WATER QUALITY RESTORATION PLAN AND TOTAL MAXIMUM DAILY LOADS (TMDL) FOR THE BOBTAIL CREEK WATERSHED

EXECUTIVE SUMMARY

Figure 6-1 Restoration Projects in the Bobtail Creek Watershed.

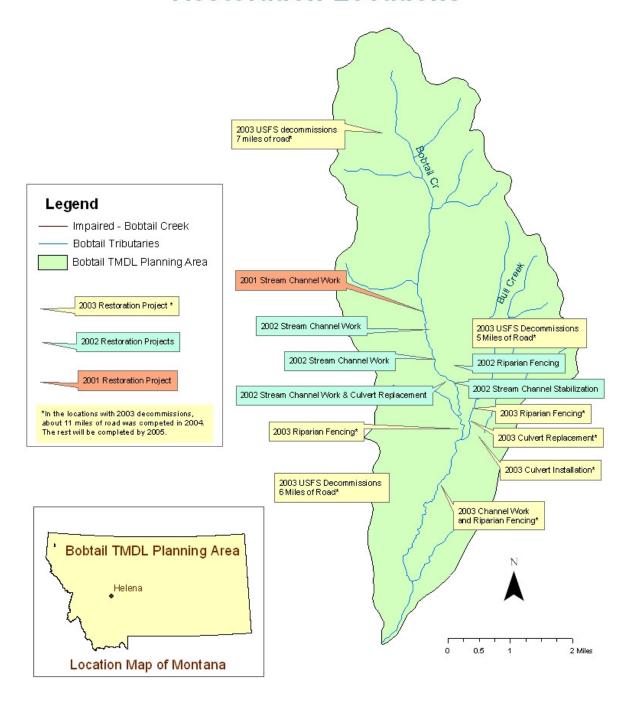
<u>Comment 12:</u> Page 72 -figure 6-1. Some of the heading in the boxes have changed due to funding shortfalls. The boxes with 2003 decommissioning should be changed to note that some of the work will not be completed till 2005. Approximately 11 miles of the road decommissioning work was completed in 2004.

Response: Figure 6.1 has been modified to reflect this comment.
